Anti-servo/trim tab drive pin replacement

Classification - Mandatory

Applicability All Europa aircraft (stage1 kits supplied prior to 1st December 2000)

Fig 1. Tab drive pin setting template - not full size.

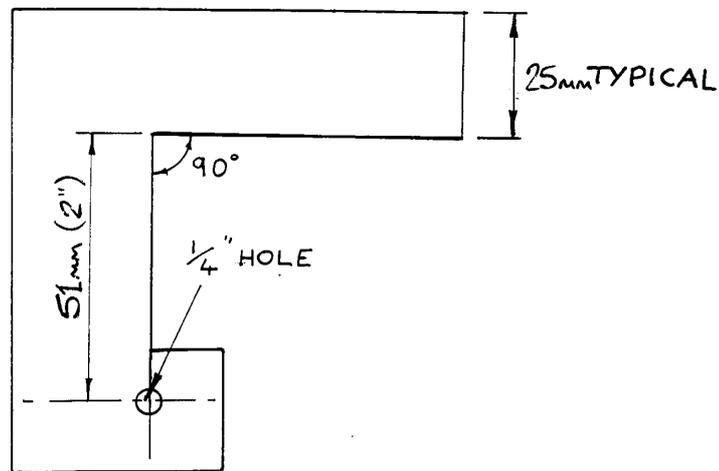
Prior to the removal of the TP16 pins from the tabs, make a template which will enable positioning of the new TP16 pins in exactly the same place as the originals. See figure 1.

It may be prudent to make a template for each tab pin as the build up of differences may affect the positioning.

Adjust each template so that they fit in place exactly.

Grind away the glassfibre which retains the pin plate until all the metal is exposed. The pin should remain attached to the tab at this stage. Place the template onto the pin so that it is flat up against the pin plate and mark on the tab surface the position of the template. The template should be at 90° to the tab hinge centre line.

Fig 2. Positioning drive pin in root of hub.

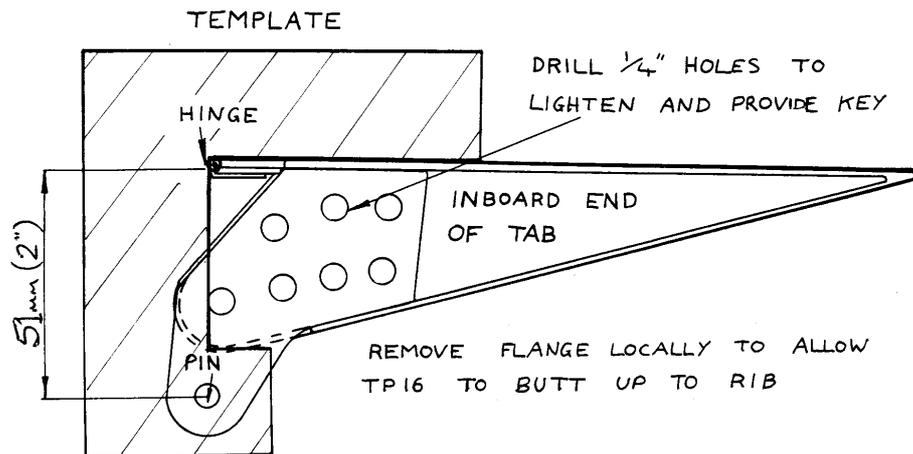
Firstly, drill a few holes through the plates of the drive pins to aid bonding and to make them lighter. The hole pattern should be similar to that shown on figure 2. Do not drill any hole with its centre less than 20mm (3/4") from the pin centre.

Also, taking care not to scratch the portion of the plate which is *not* to be bonded, scuff sand the surface of the plate to aid bonding. Refer to figure 2.

Fig 3. Tab with drive pin attached.

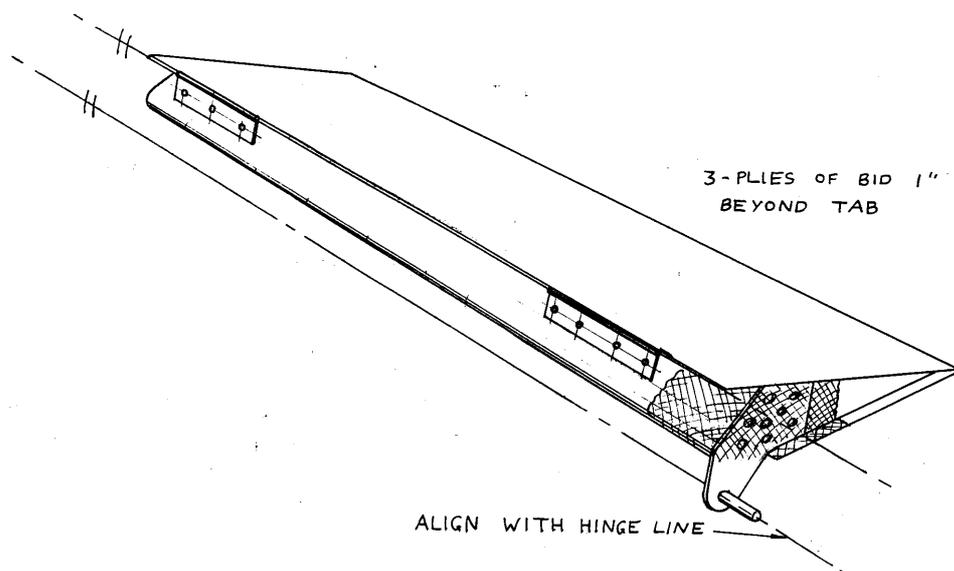
Referring to figures 2 and 3, and using your template, align the drive pin TP16P or TP16S so that the pin is in line with the hinges. As the tab's root is angled relative to the aircraft centreline a fillet of dryish flox is required behind the TP16's to align them correctly.

Allow the floc to squeeze through the holes to give a good key then cover the plate with peel ply then allow to cure ensuring alignment is not disturbed.

Remove the peel ply, then layup 3 plies of 'bid' at $\pm 45^\circ$ over the TP16, extending this layup around the leading edge of the tab and the top and bottom flanges, then peel ply all the edges.
